# PARTS & SERVICE NEWS

REF NO.	AA01142
DATE	July 10, 2001

**SUBJECT:** REPAIR TO IMPROVE WATERPROOF-ABILITY OF T/M CONTROLLER MOUNTING SECTION

**APPLICATION:** WA250-3PT Wheel Loader Serial Number A75039 thru A75312  
WA250-3L Wheel Loader Serial Number A70112 thru A70432  
WA250-3MC Wheel Loader Serial Number A71007 thru A71331  
WA250PT-3MC Wheel Loader Serial Number A78027 thru A78067

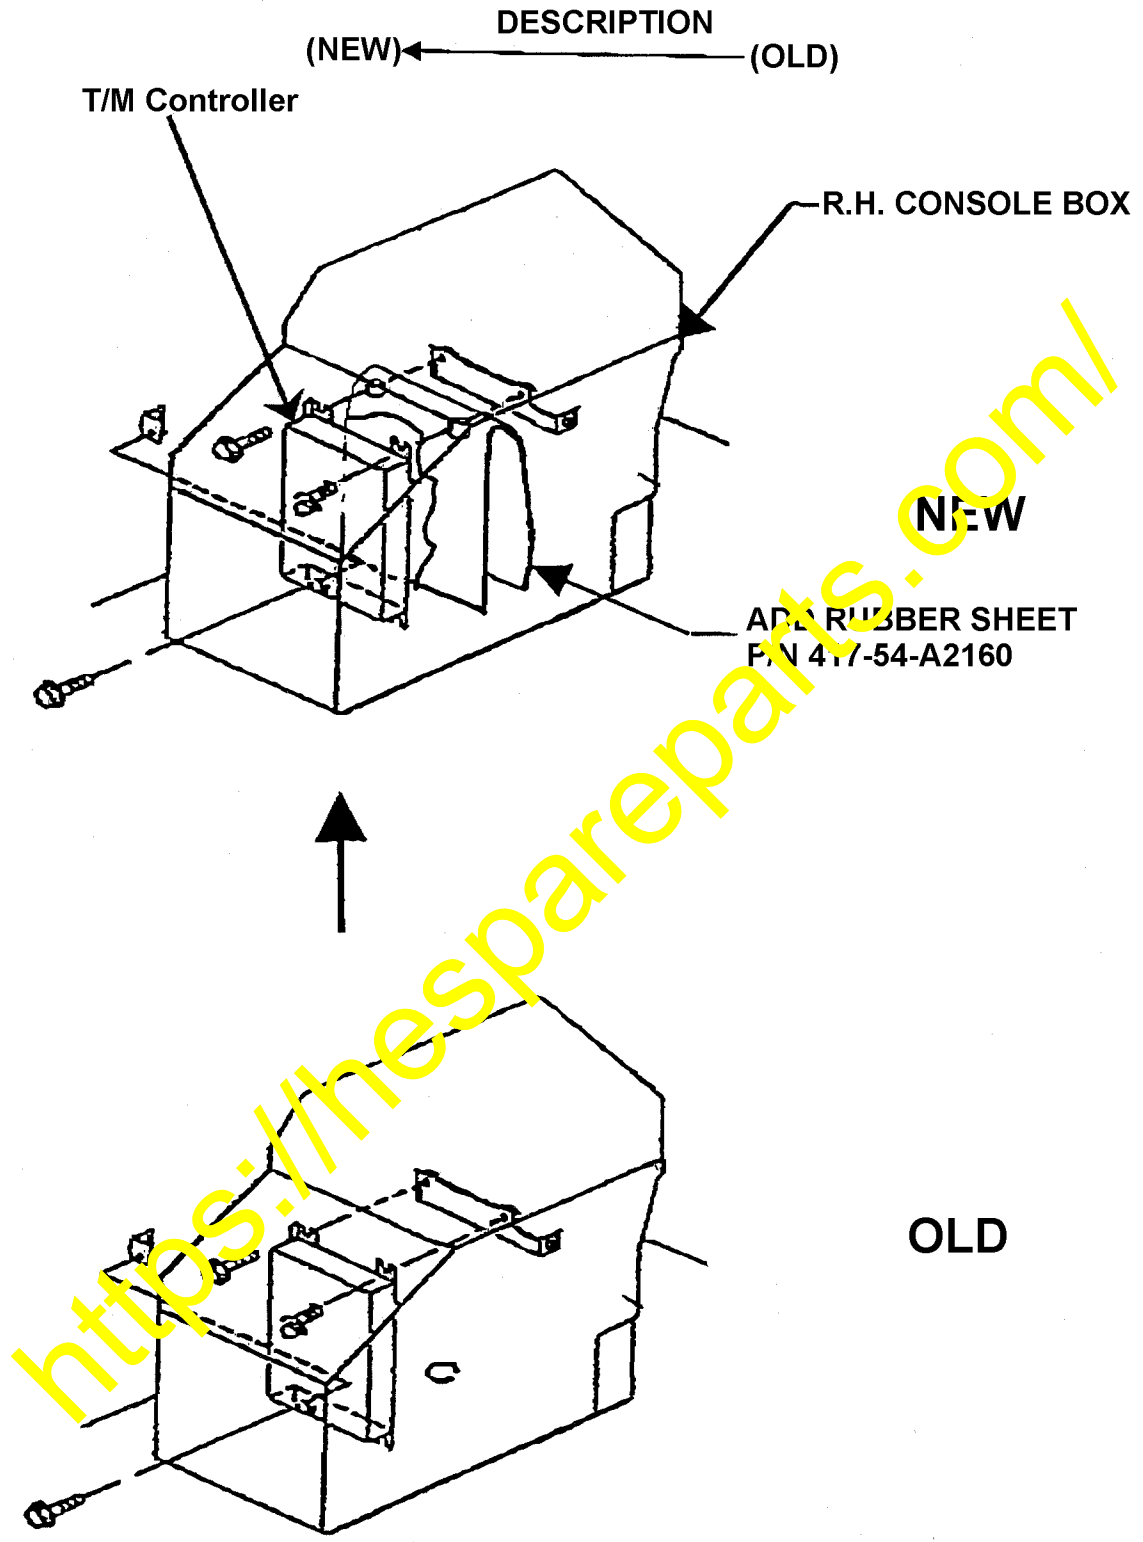
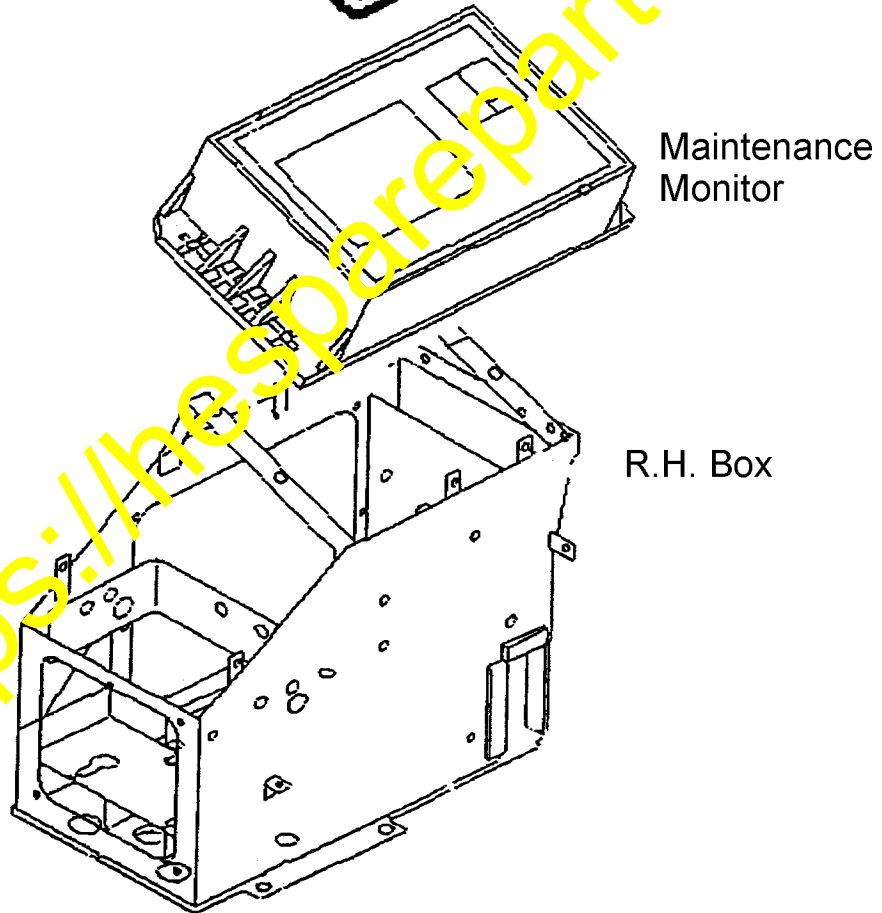
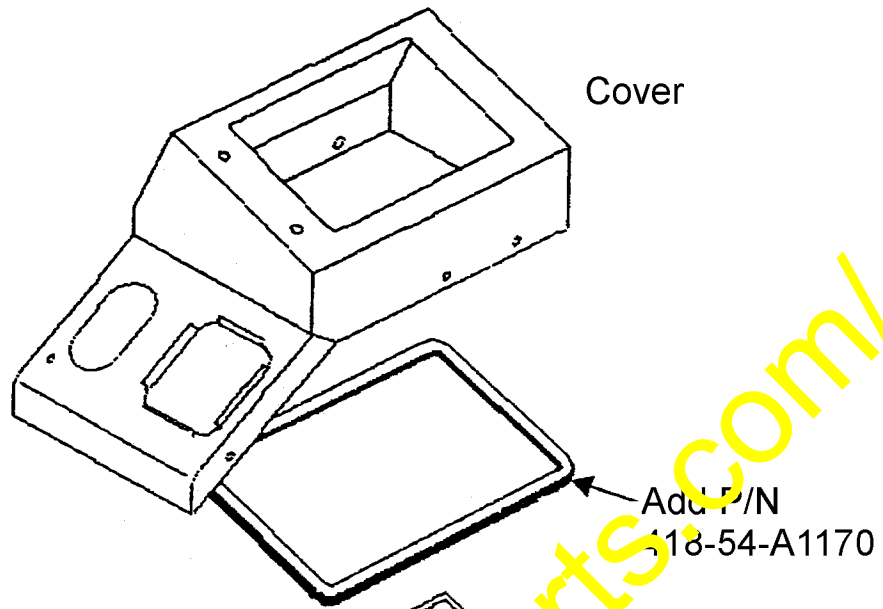
**PURPOSE:** To introduce modification procedures to improve the water proofing capability of the tranmission controller mount section. (Canopy or cab-less, Canopy-less with automatic shift transmission)

The WA250-3 Wheel Loaders equipped with the open ROPS canopy and the auto-shift transmission have experienced controller failures due to water entering the controllers. This **Parts and Service News** introduces a countermeasure to prevent water intrusion of the transmission controller.

Part No.	Part Name	Purpose of part	Q'ty	Remarks
417-54-A2160	Sheet-rubber	Additional	1	
418-54-A1170	Seal	Additional	1
